3Foxes Biodiversity Solutions
 23 De Villiers Road
 Kommetjie
 7975
 15 May 2021

RE: Highlands Central Wind Energy Facility (WEF) Amendment Application

Figure 1. The sensitivity map for the Highlands Central WEF showing the original layout left and the proposed amended layout right.

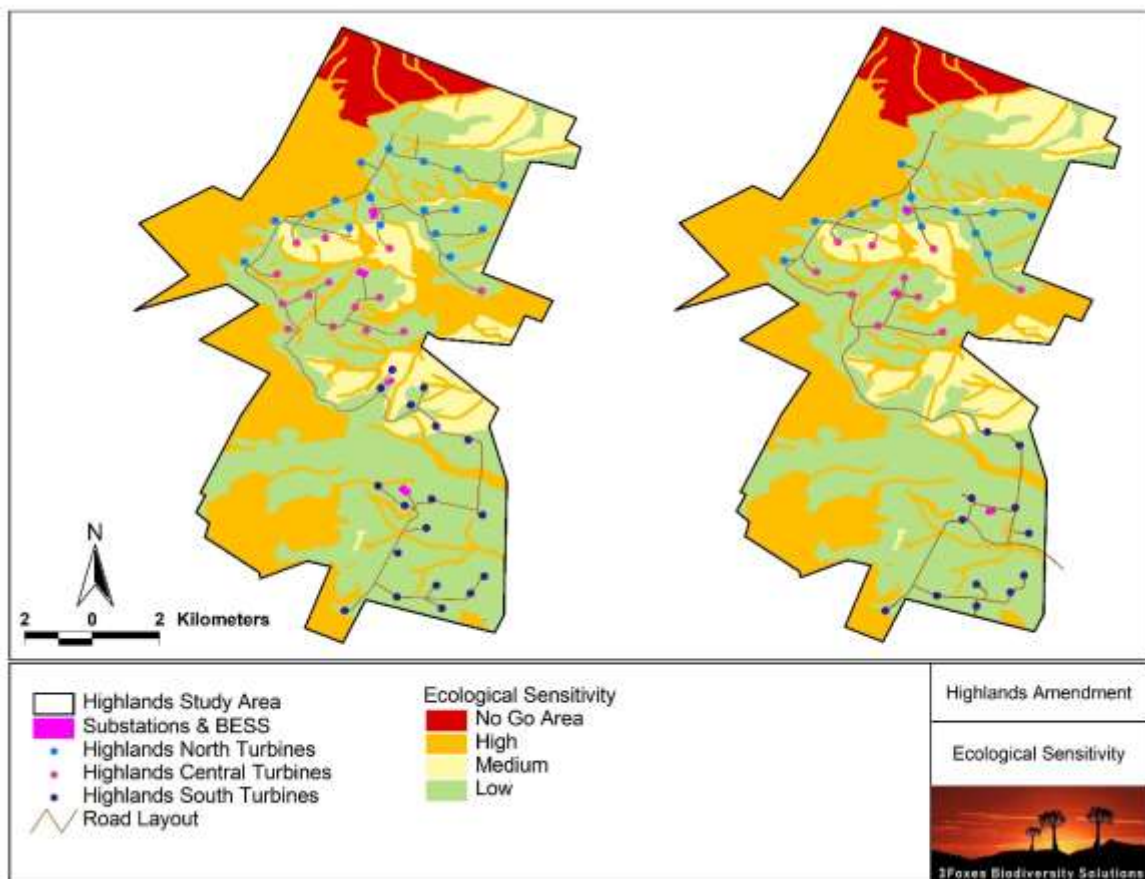
The sensitivity map for the Highlands Central WEF, showing the original assessed layout and the revised proposed amended layout is illustrated below in Figure 1. The distribution of turbines and associated infrastructure in relation to the sensitive features of the site are little changed between the original assessment and the amendment. As a result, there do not appear to be any significant advantages or disadvantages of the proposed amendments, including the amended layout.

The proposed amended layout of the Highlands Central WEF is located in similar areas to the original footprint and there are no turbines in High or Very High sensitivity areas under either the original or amended layout. In addition, there are no new or additional impacts associated with the proposed amendments, including amended layout, with the result that there are no recommended changes to the mitigation and avoidance measures that were included in the original Fauna and Flora specialist BA study. In addition, the cumulative impacts associated with the amendment are considered to be similar to those as assessed in the BA and thus there would be no changes to the overall cumulative impacts associated with the change. All of the mitigation and avoidance measures as recommended in the Fauna and Flora specialist BA are upheld by the current study and should be applicable to the amended layout as well.
